**SAN ANTONIO WATER SYSTEM  
CENTRAL WATER INTEGRATION PIPELINE  
SEGMENT 5-4  
SAWS Job No. 18-8614  
SAWS Solicitation No. CO-00182**

**ADDENDUM No. 2  
November 6, 2018**

**SAN ANTONIO WATER SYSTEM**  
 CENTRAL WATER INTEGRATION PIPELINE  
 SEGMENT 5-4  
**STORM WATER POLLUTION PREVENTION PLAN**

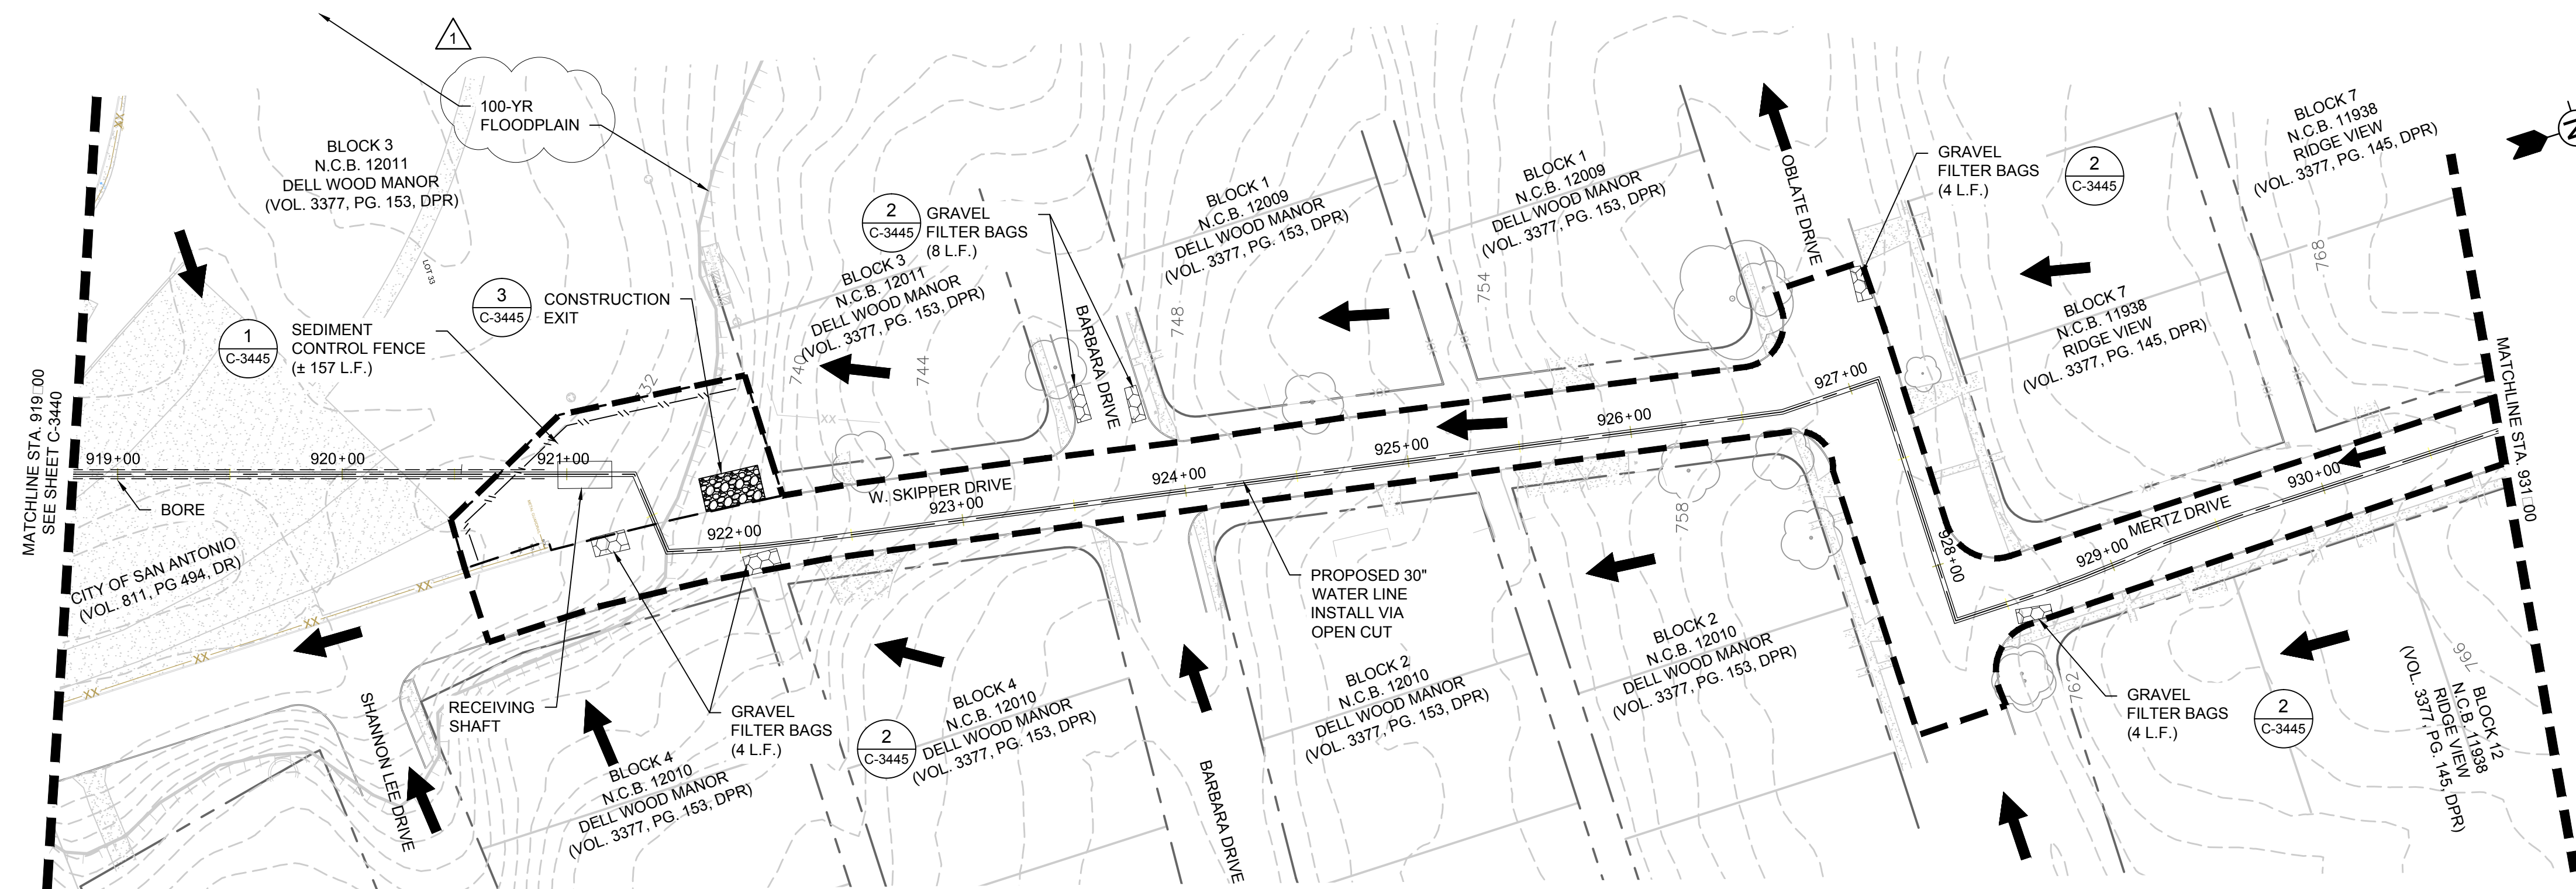
**ADDENDUM 2 REVISIONS:**  
 1. REMOVED SEDIMENT CONTROL FENCE AND GRAVEL FILTER BAGS AT END OF BASIN DR. AND ADDED ROCK FILTER DAM TYPE II.  
 2. ADDED & LABELED 100-YR FLOODPLAIN LIMITS.  
 3. ADDED FLOODPLAIN NOTE.

**SAN ANTONIO WATER SYSTEM**  
 CENTRAL WATER INTEGRATION PIPELINE  
 SEGMENT 5-4  
**STORM WATER POLLUTION PREVENTION PLAN**

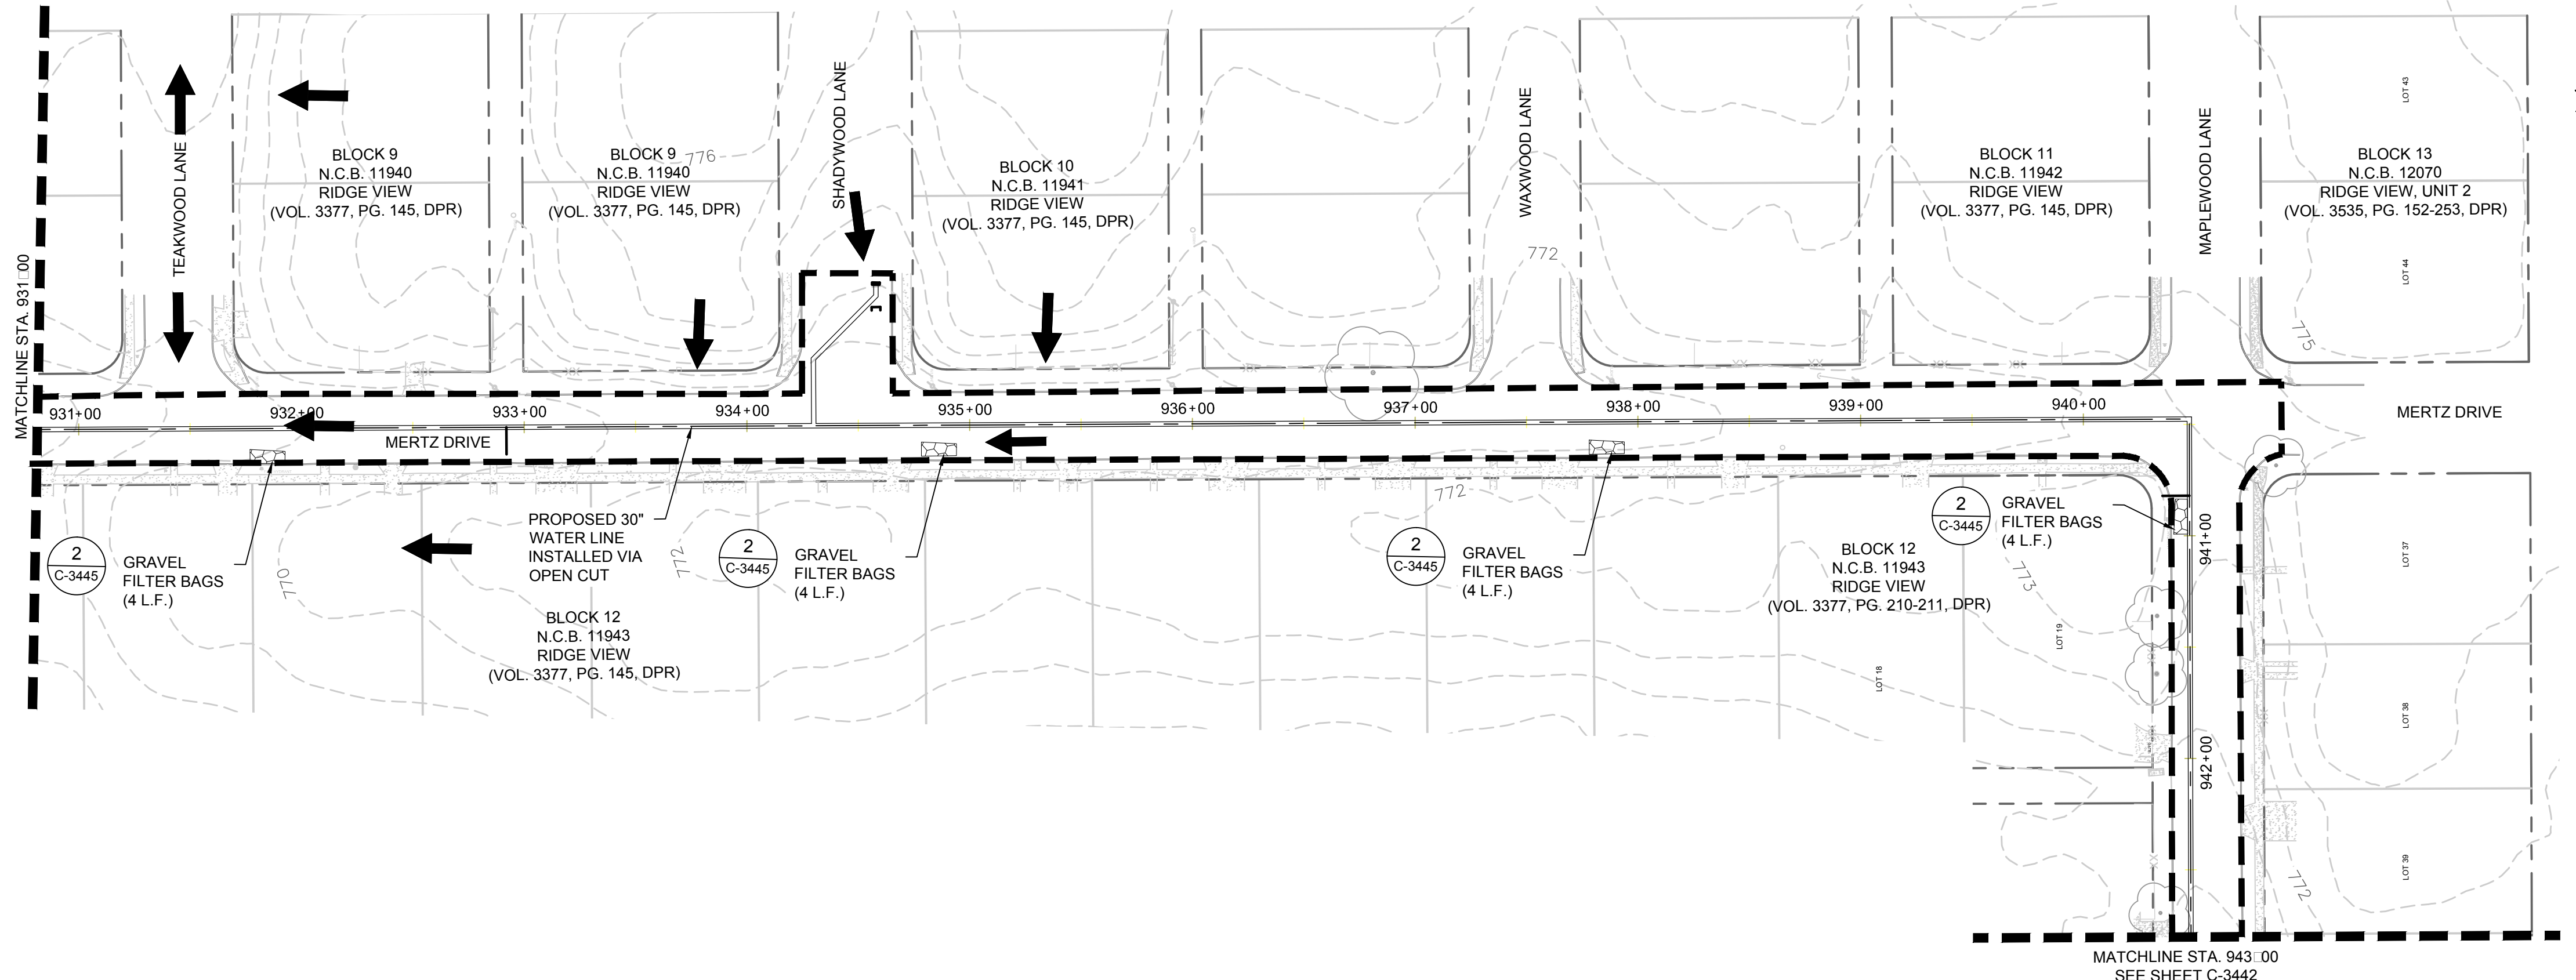
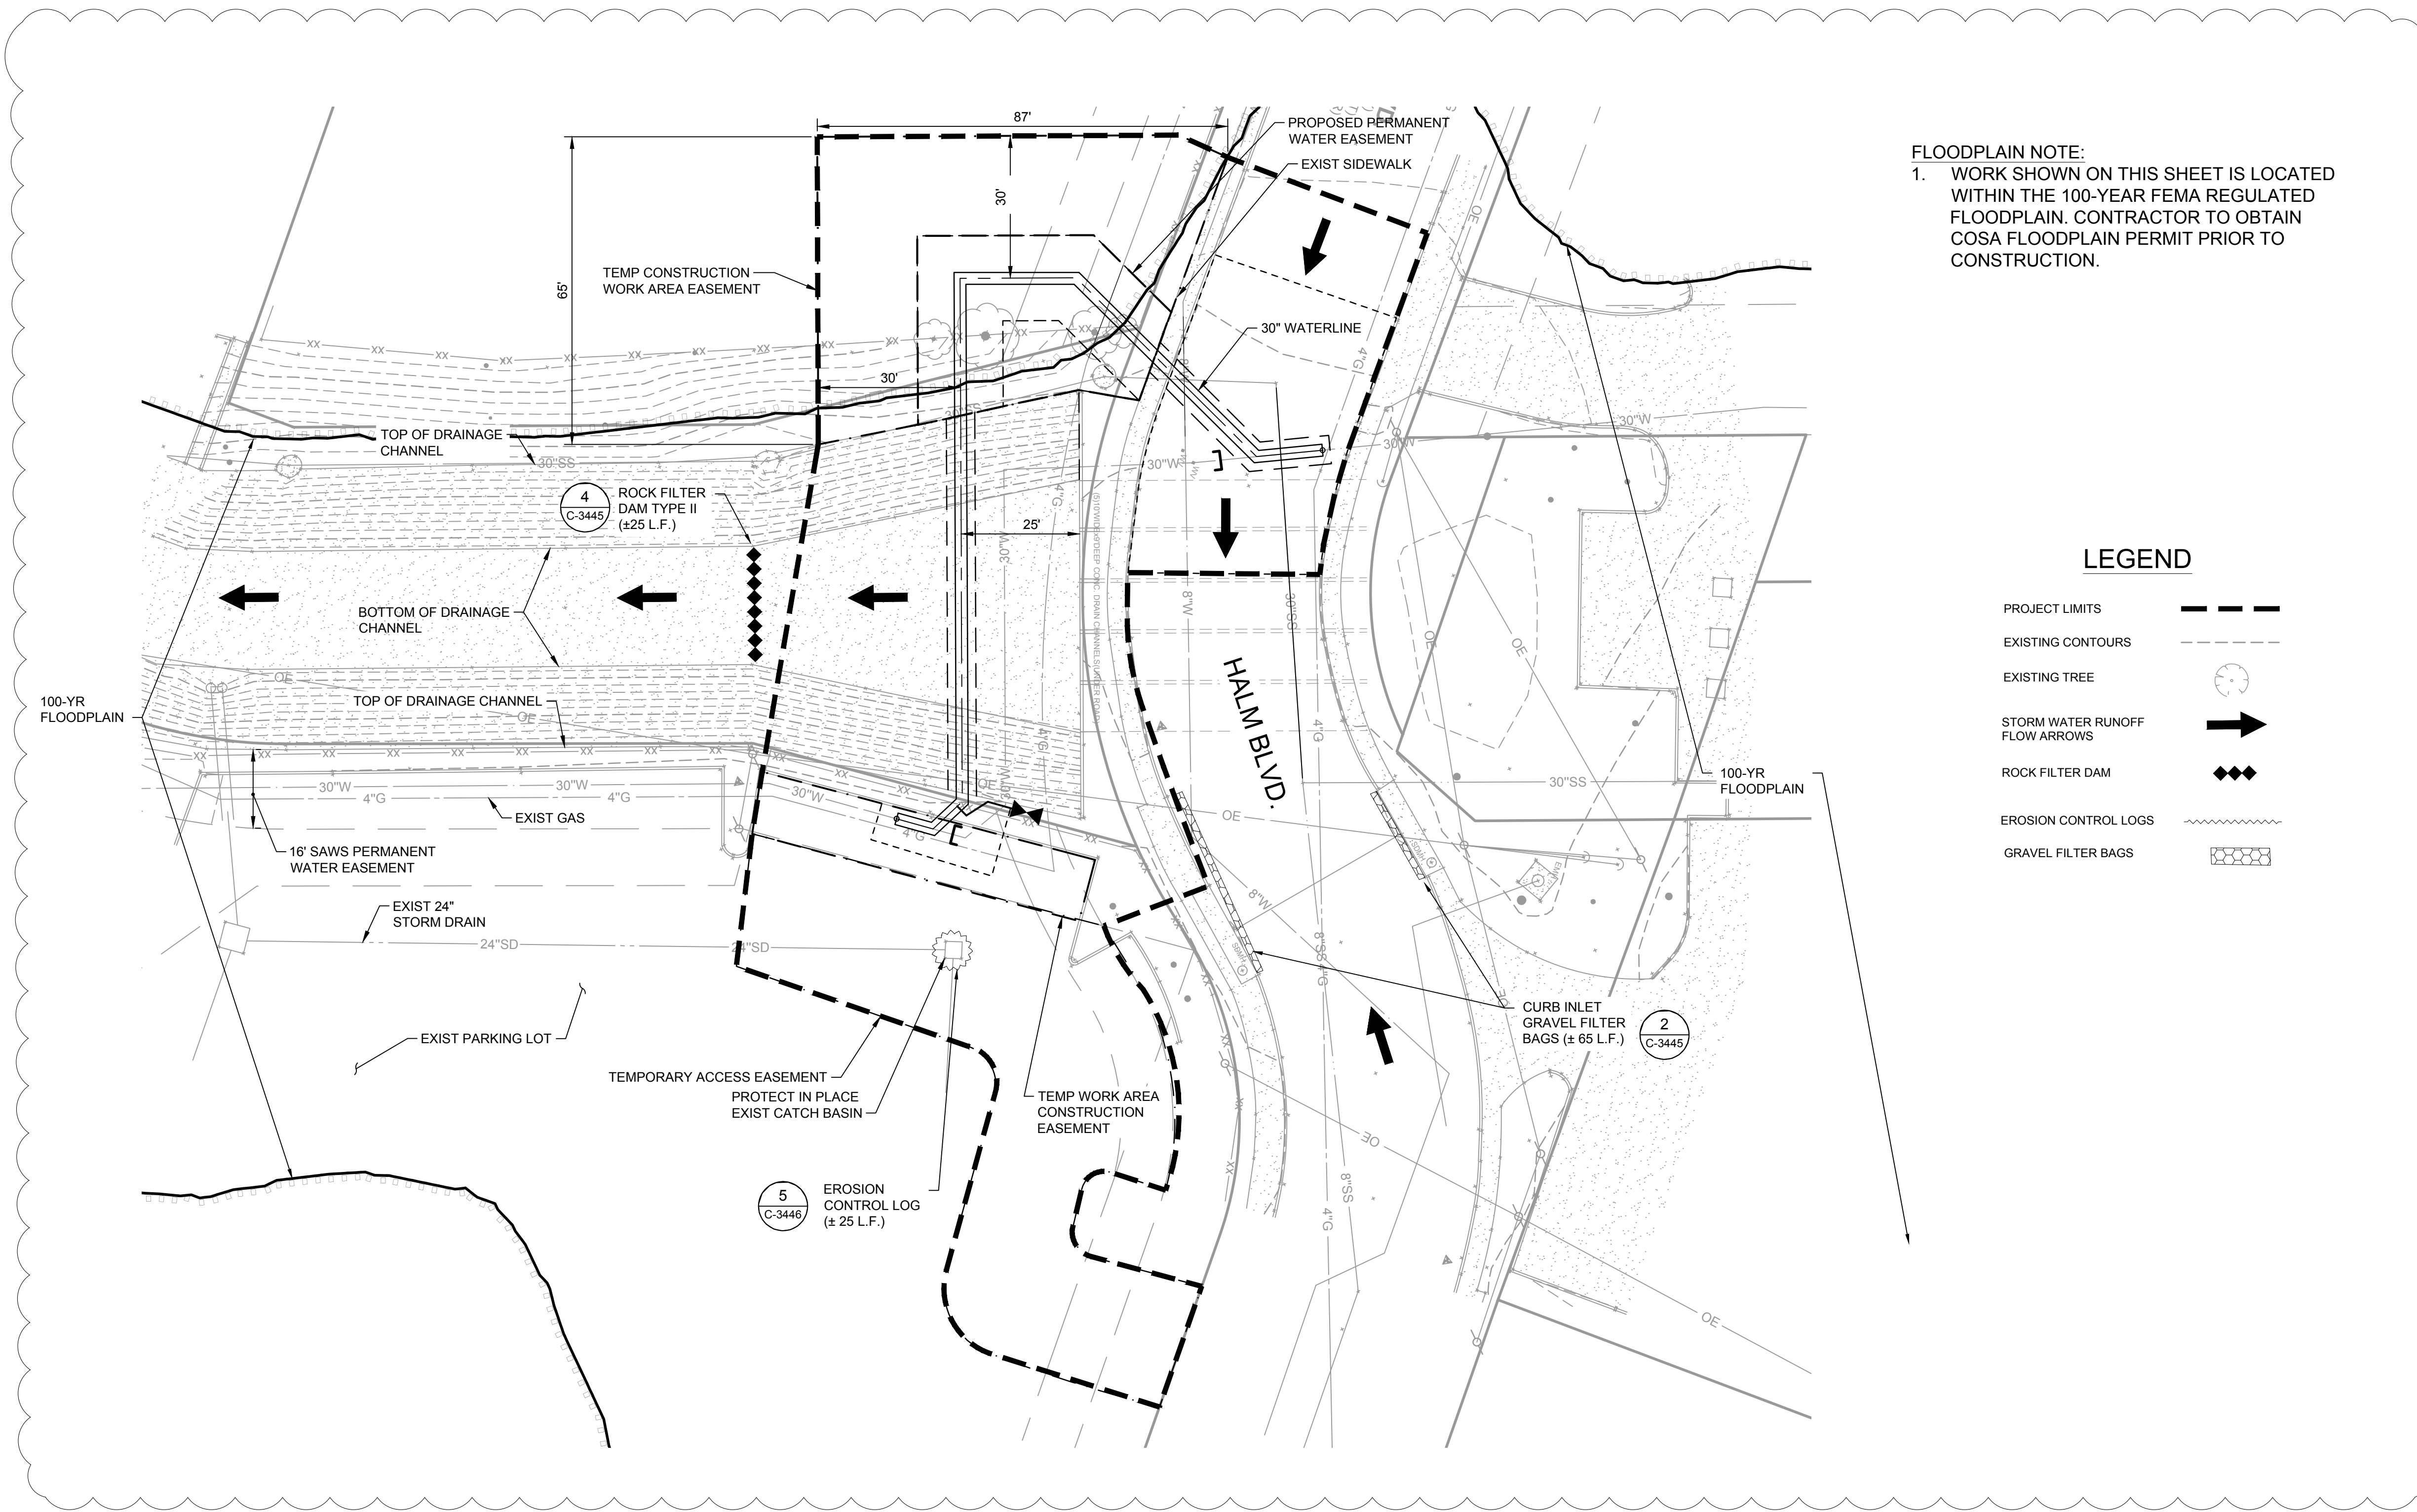
**ADDENDUM 2 REVISIONS:**  
 1. ADDED & LABELED 100-YR FLOODPLAIN LIMITS.  
 2. ADDED FLOODPLAIN NOTE.
